Subject:	Town of Cumberland Town Office Parking Expansion -Major Site Plan Review
From:	Carla Nixon, Town Planner
To:	Town of Cumberland Planning Board
Date:	April 16, 2020

Subject:Town Office Parking ExpansionTown of Cumberland Site Plan Review ApplicationResponse to Peer Review Comments dated 4/13/2020

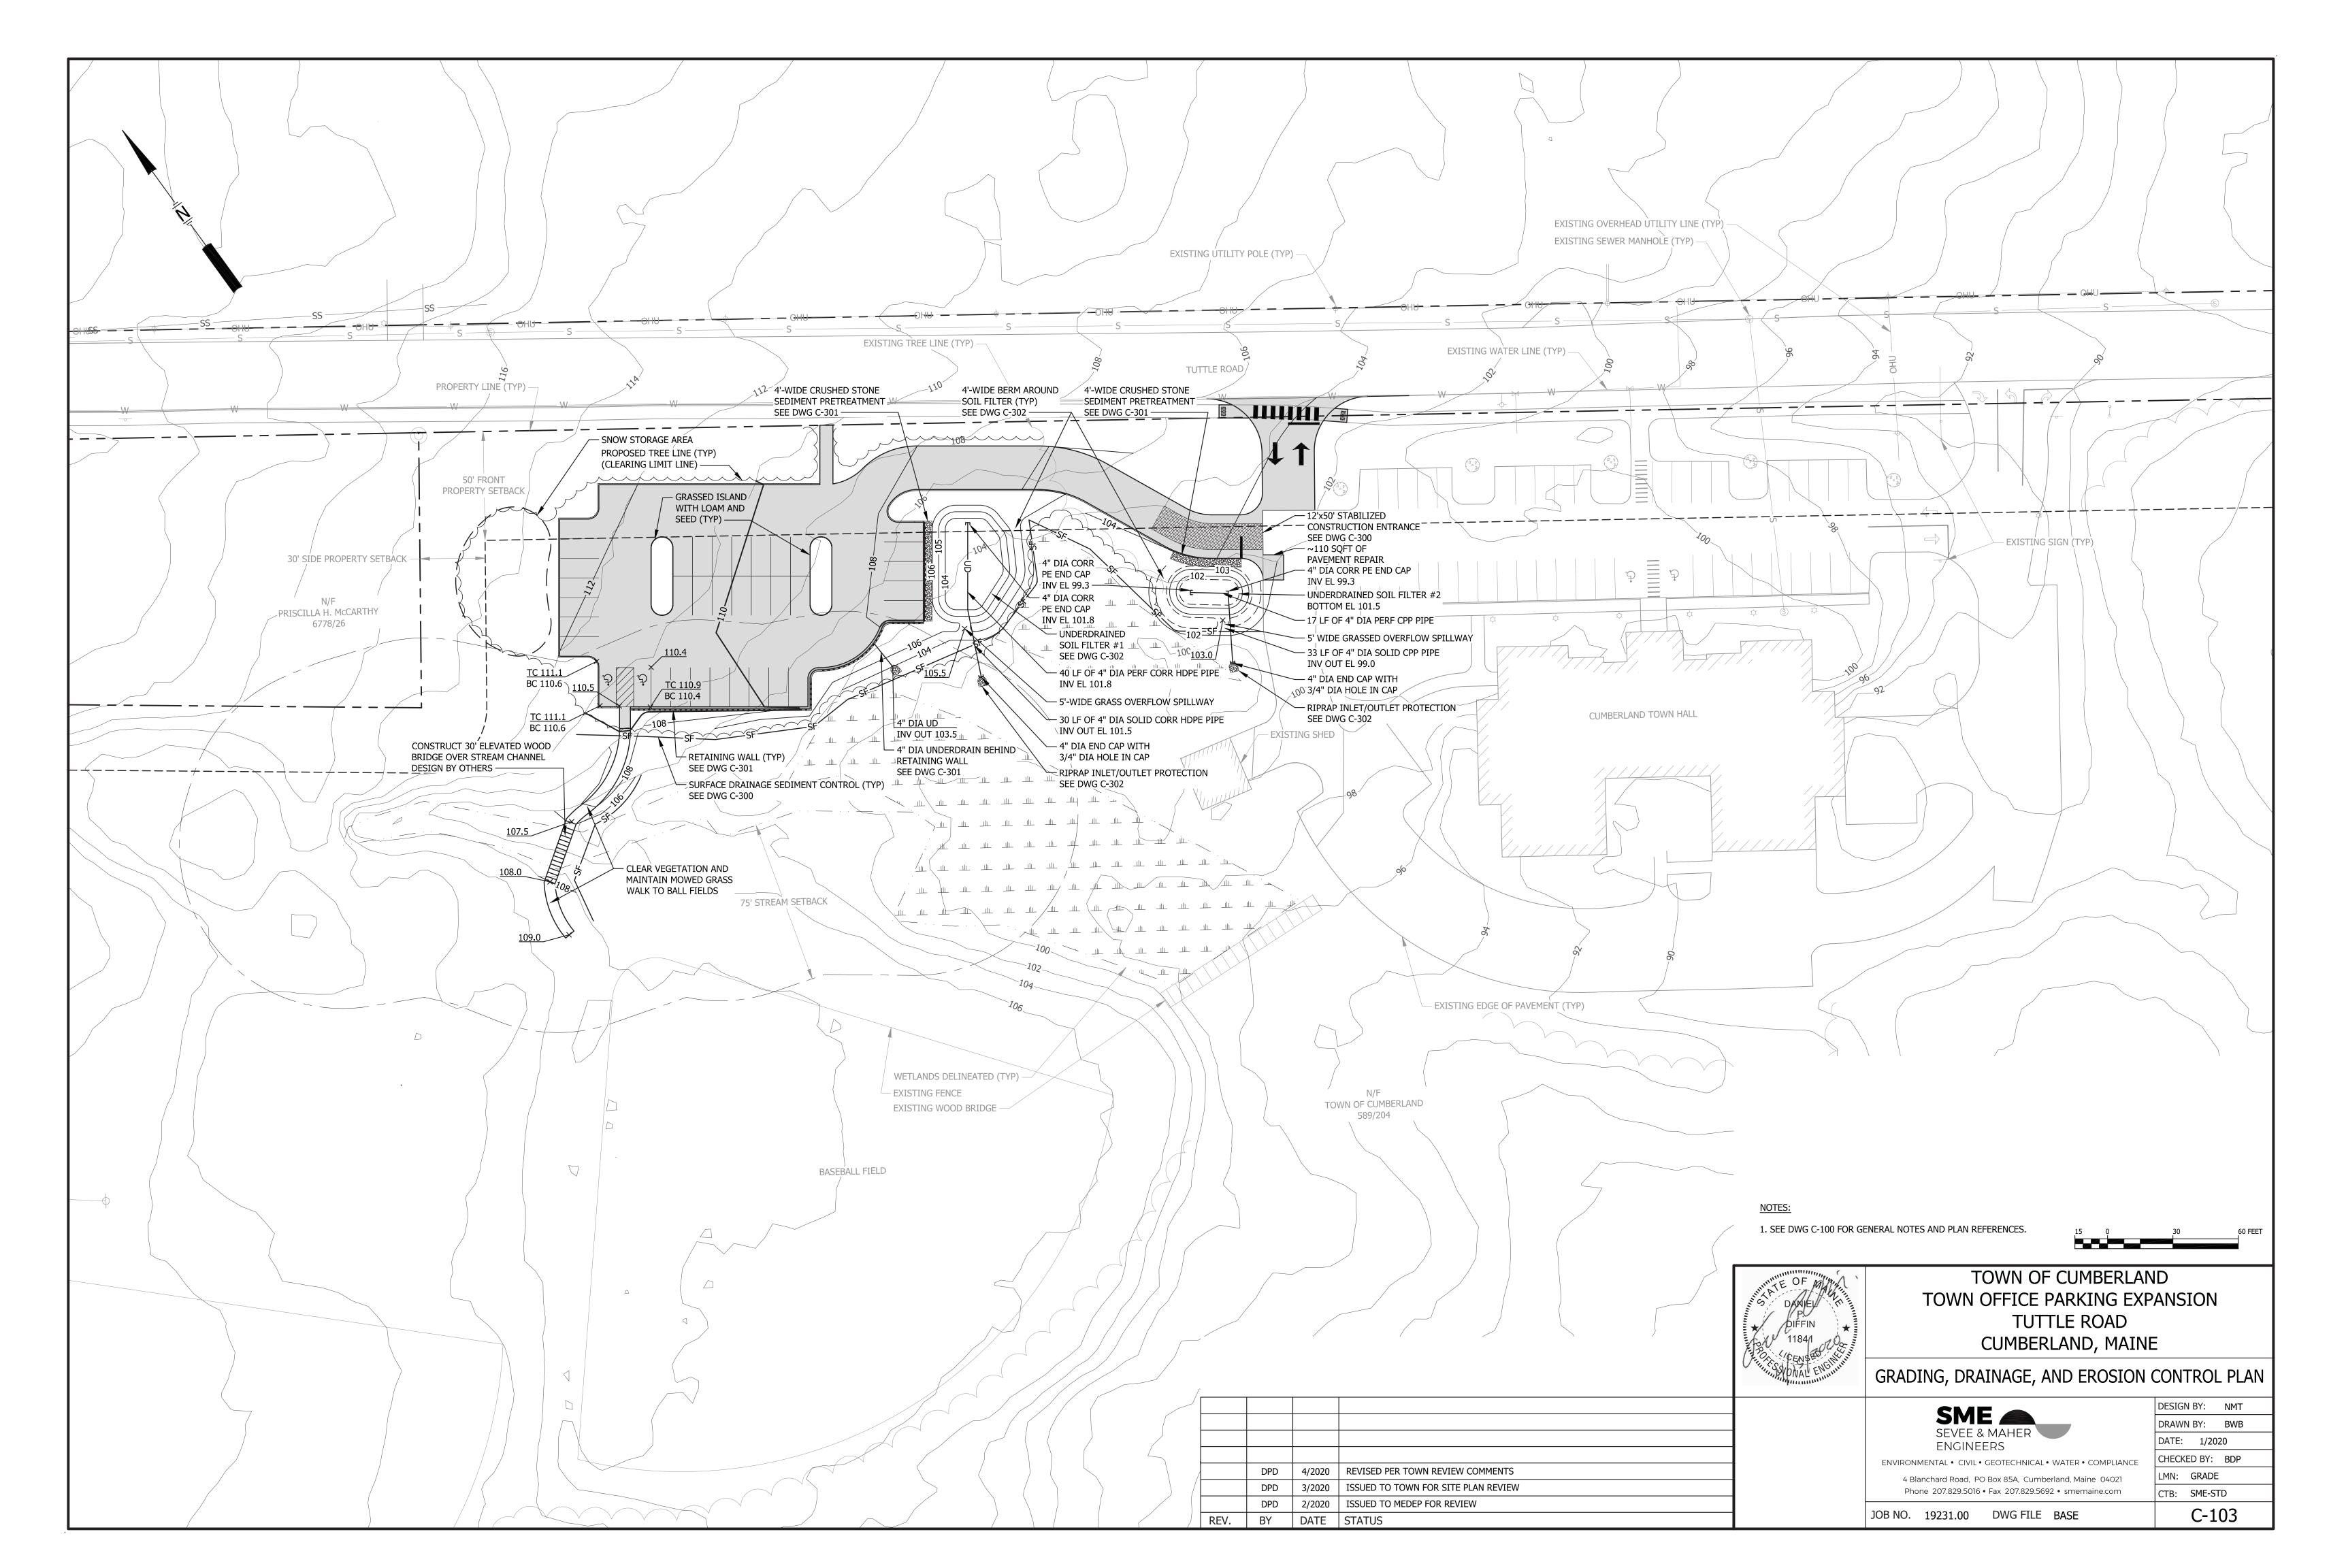
- Show spillway size for UDSF 2 on plans
 - Show berm width on plans
 - Show typical berm section on plans
 - Show orifice detail on plans
 - Correct reference to 41 If 12" pipe adjacent to UDSF 2 on plan sheet C103

- Site Plans
 - Site Layout Plan (C-103)
 - No pedestrian connection is shown between the satellite parking area and the main parking field for the Town Office. If the satellite parking area is going to be used for overflow voter parking, is it desirable to have people using the connecting driveway as the primary pedestrian route as well, considering the driveway is only 20' in width.

- Show stop sign/stop bar at access drive/Tuttle Road intersection
 - Designate accessible ramps at the existing sidewalk intersection with the proposed drive.

<u>SME Response</u>: The spillway for UDSF 2 is a 5-foot wide grass overflow. Drawing C-103 has been updated.

<u>SME Response</u>: Drawing C-103 has been updated to indicate the 4-foot berm width.

<u>SME Response</u>: Notes were added on drawing C-103 a cap on the end of the 4-inch underdrain pipes with a $\frac{3}{4}$ -inch orifice drilled into it.

<u>SME Response</u>: The reference to "41 LF of 12" pipe" was removed form Drawing C-103.

<u>SME Response</u>: The two parking areas will be connected by the 6' paved sidewalk connection shown on drawings C-102. A sign has been added to direct pedestrians to use the sidewalk connection instead of walking on the 20-foot wide connecting driveway.

<u>SME Response</u>: Drawing C-102 was updated to show a painted stop line and stop sign at the new access from Tuttle Road.

<u>SME Response</u>: Drawing C-102 was updated with accessible sidewalk ramps at the new access and a detail was added to drawing C-301.

<u>SME Response</u>: Spot grades were added to the accessible parking and walkway, as shown on Drawing C-103.

C-300

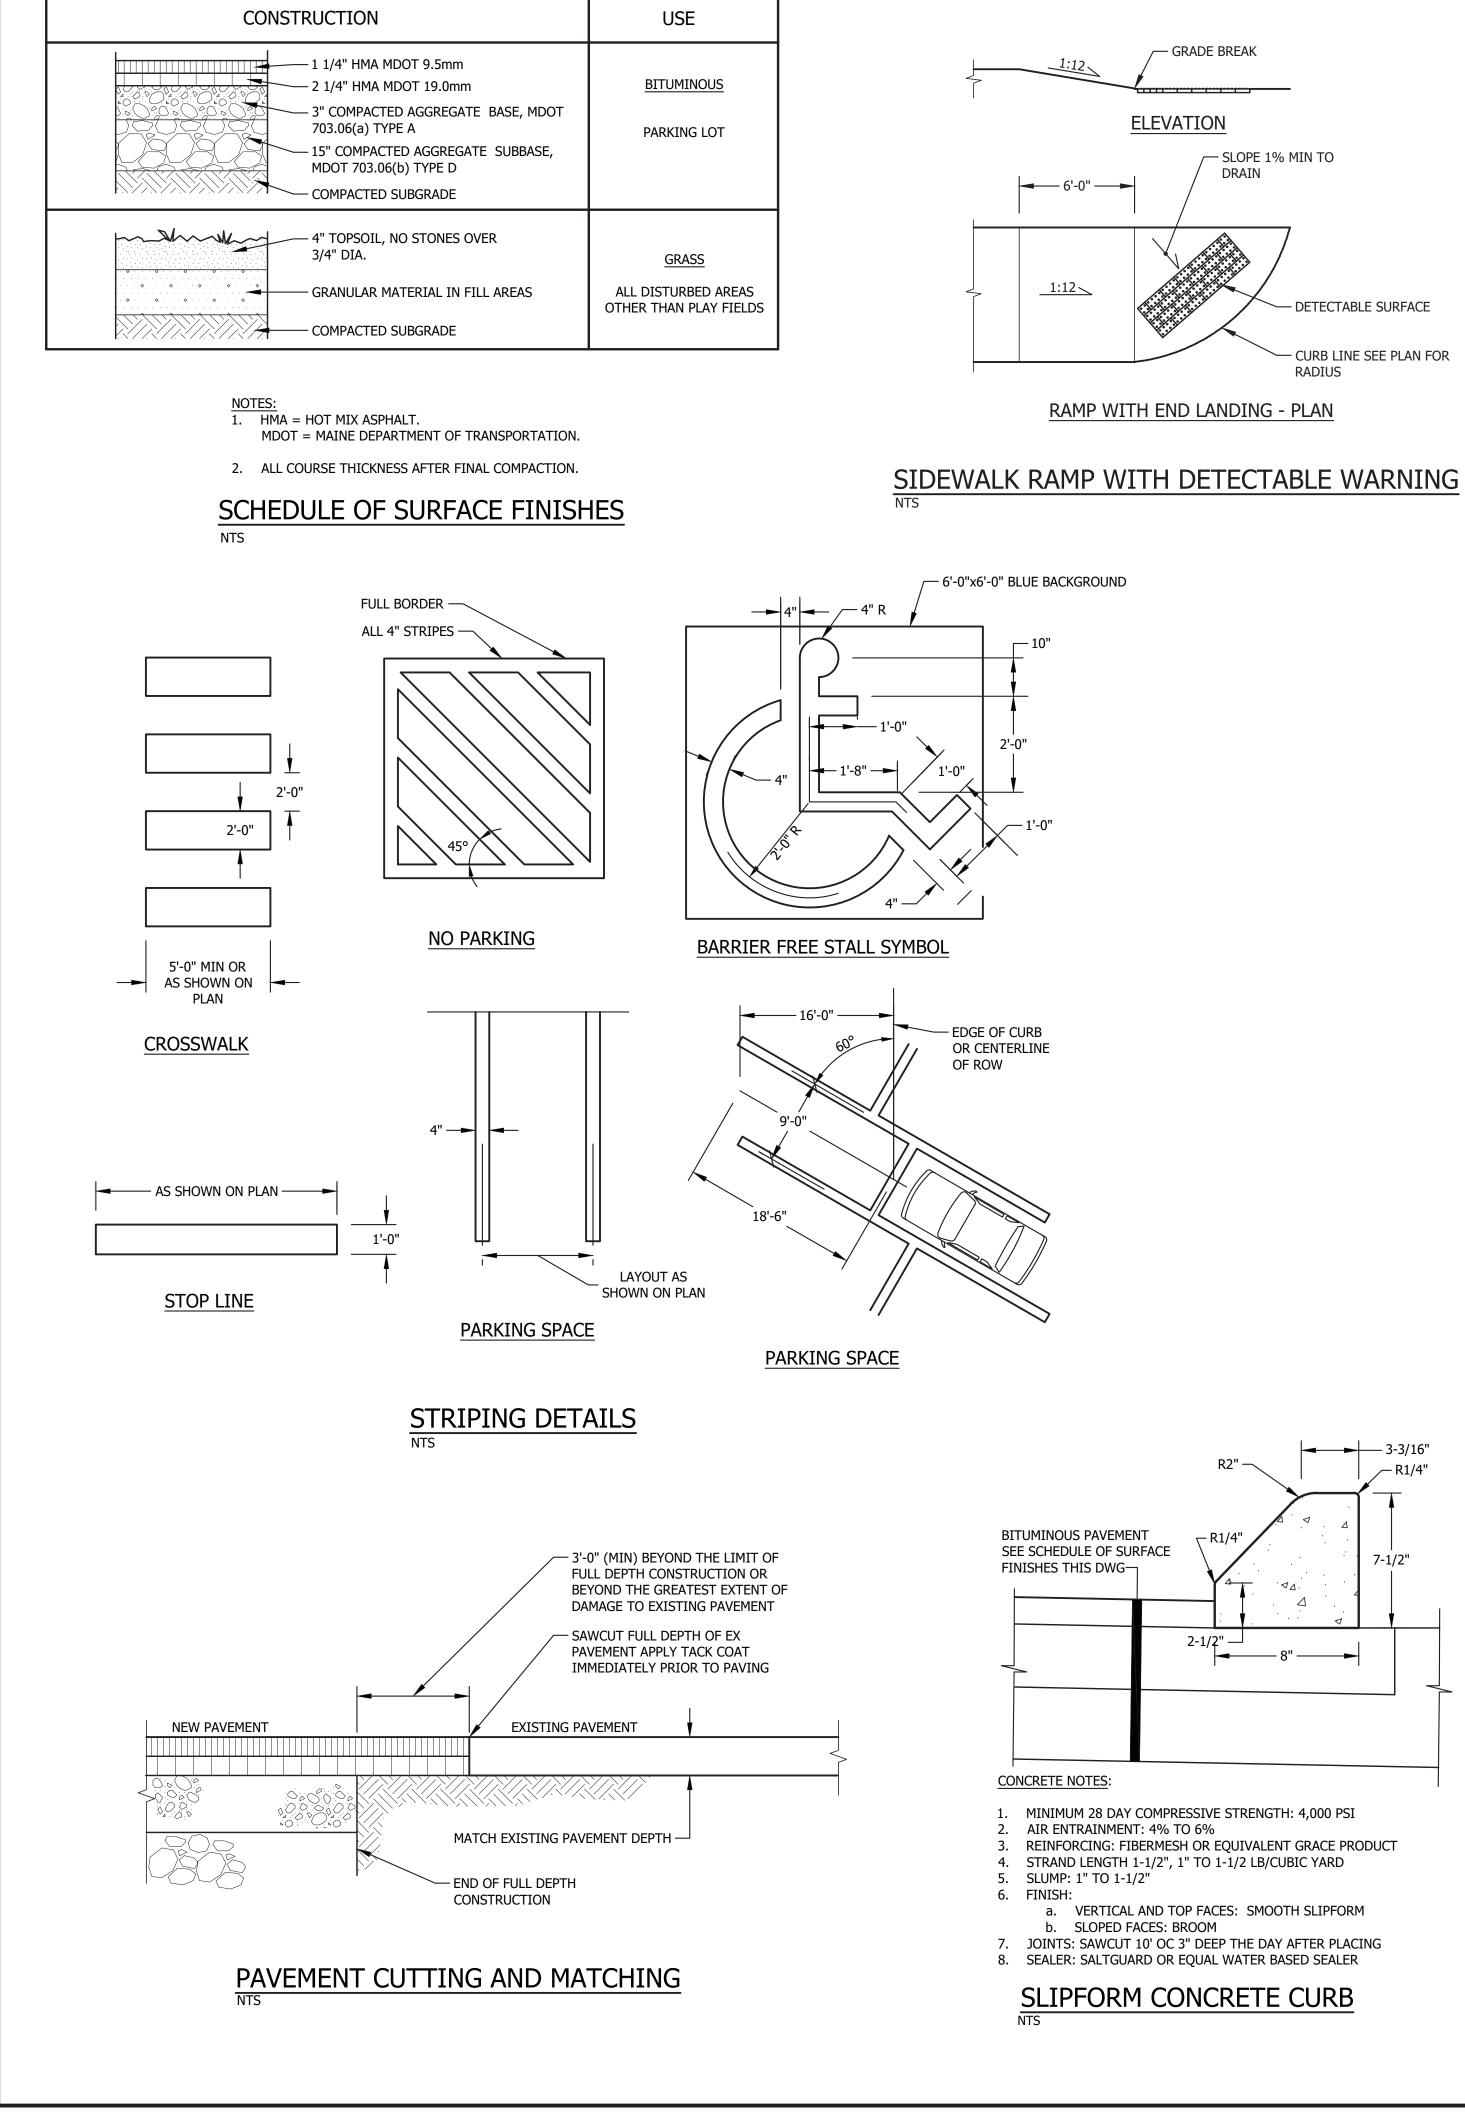
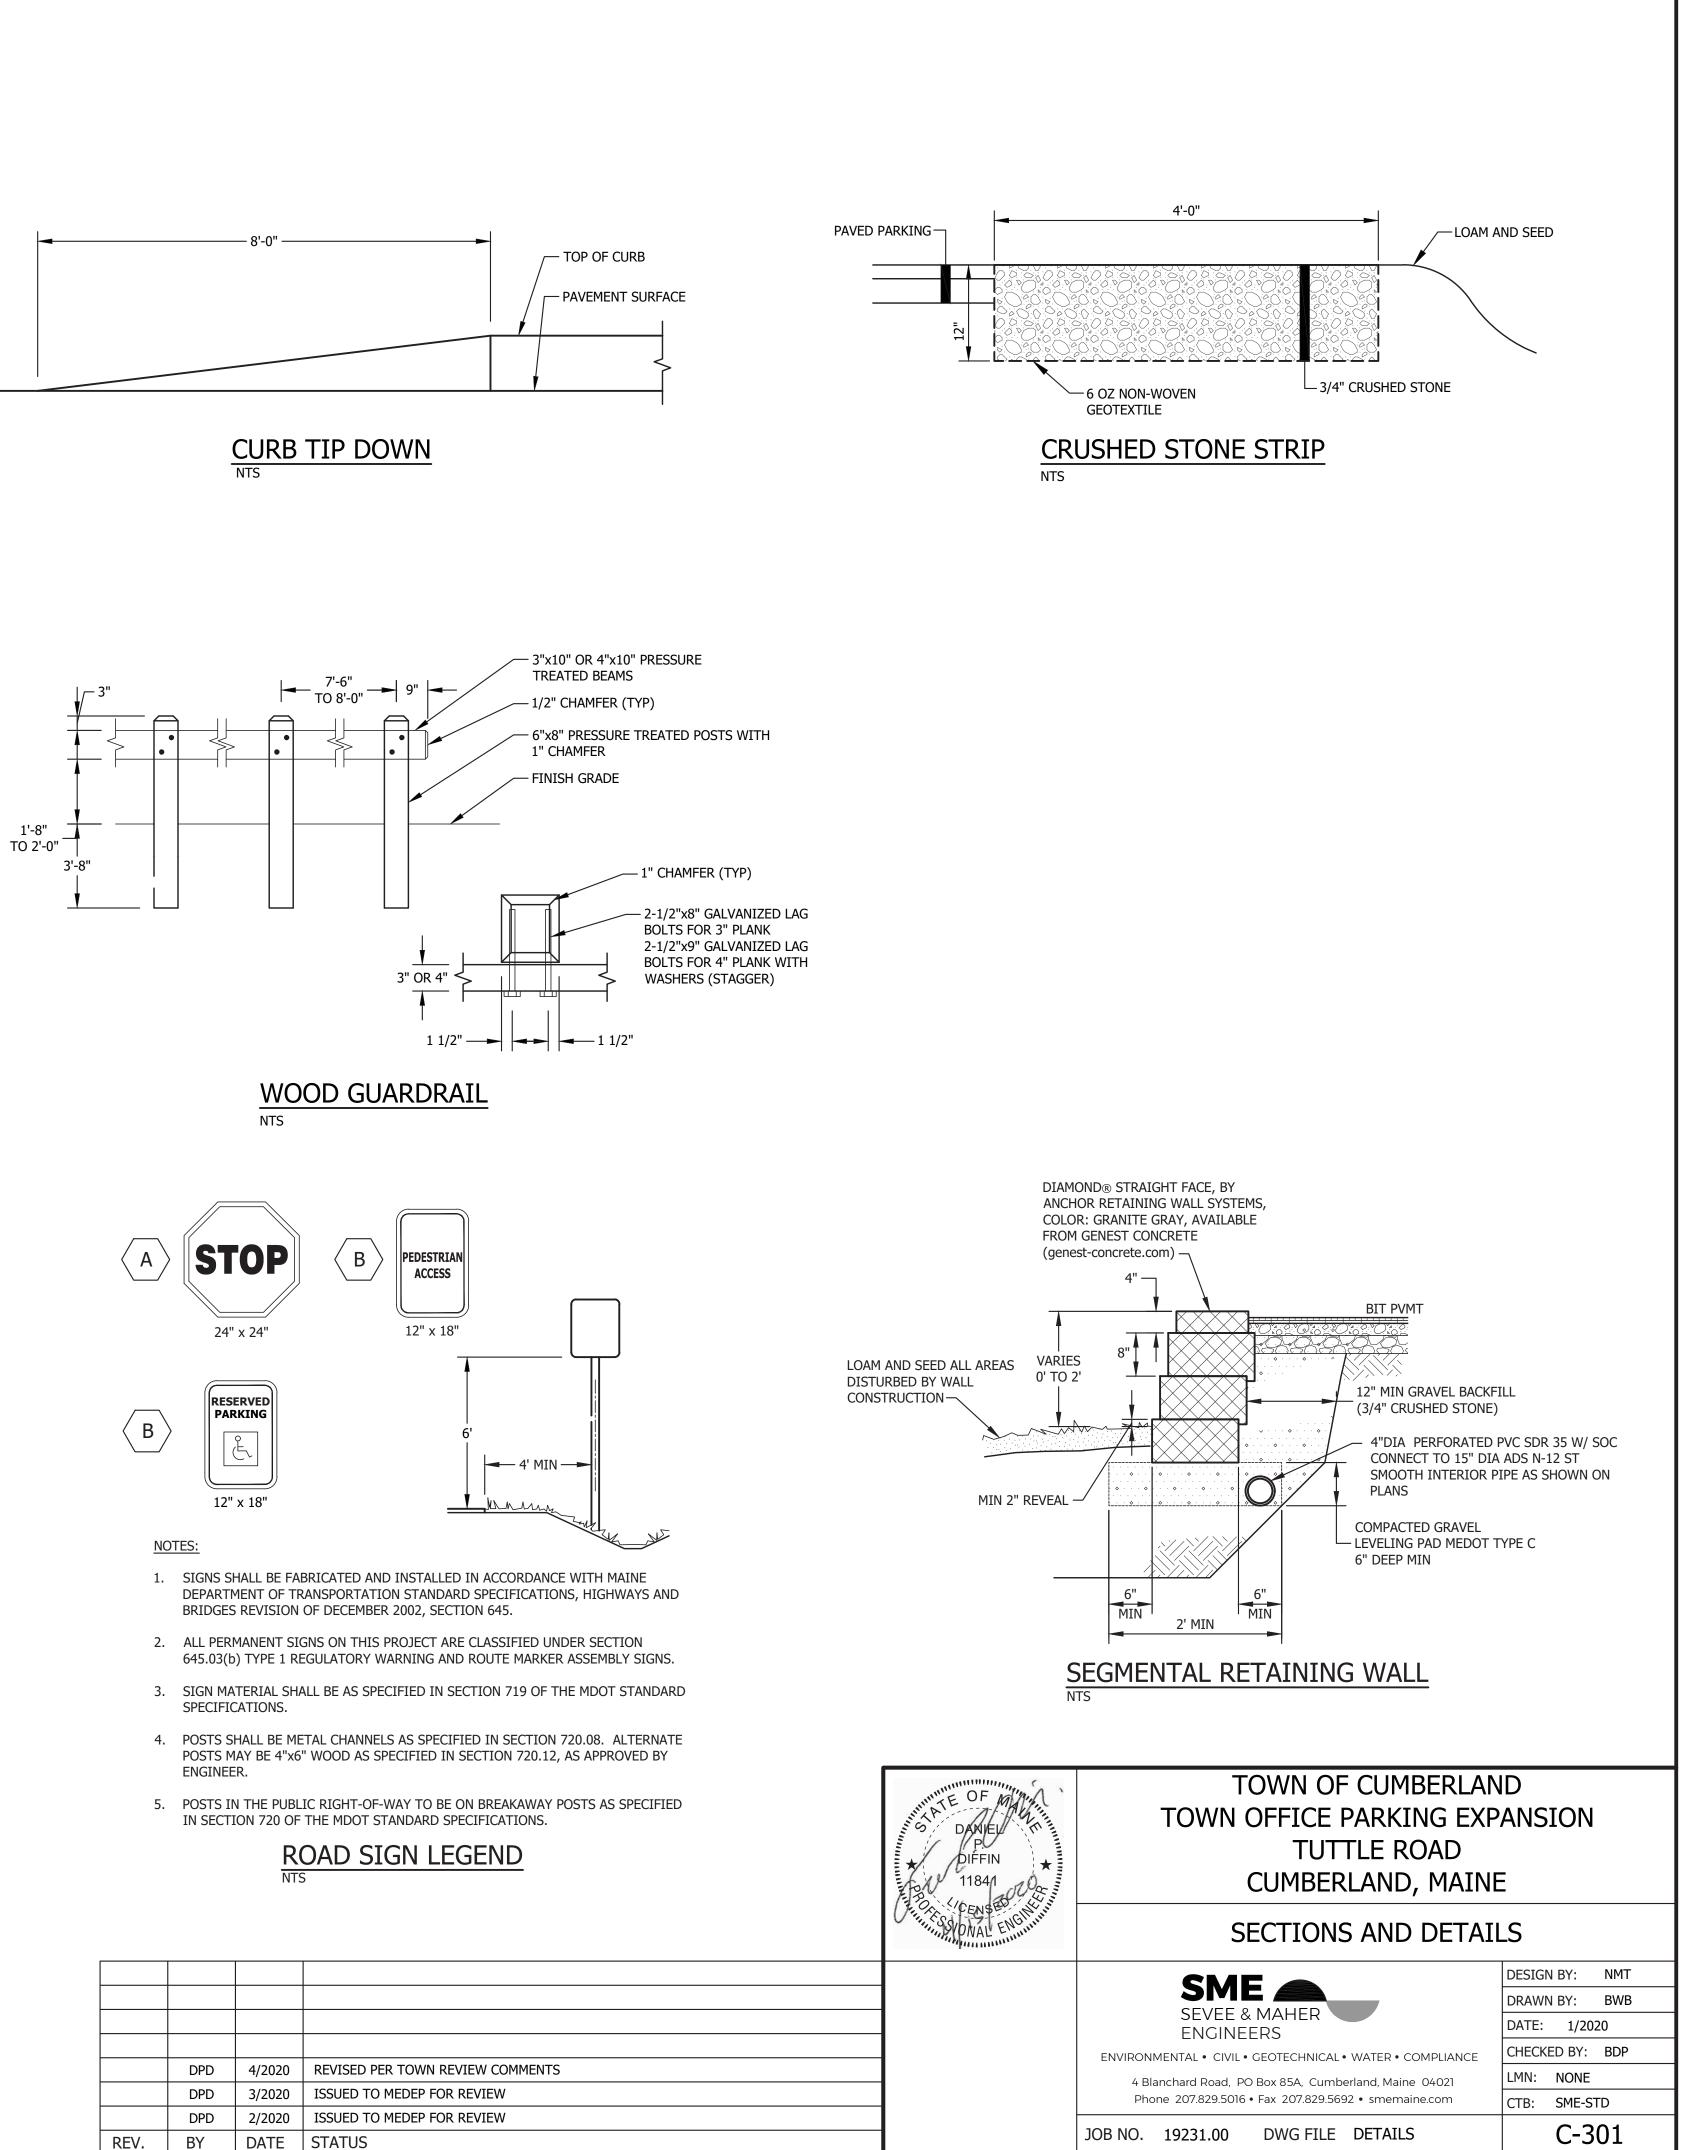
- With respect to the Stormwater Analysis and Plans, we offer the following comments:
 - Provide temporary seeding mix on plan sheet C300
 - Correct typo in Section 6.C Mulch on plan sheet C300

- With respect to the Stormwater Analysis, we offer the following comments:
 - Provide temporary seeding mix on plan sheet C300

Correct typo in Section 6.C Mulch on plan sheet C300

<u>SME Response</u>: A mix for temporary seeding was added to Drawing C-300 in accordance with the Maine Erosion and Sediment Control Practices Field Guide for Contractors.

<u>SME Response:</u> Typo on Drawing C-300 has been corrected.
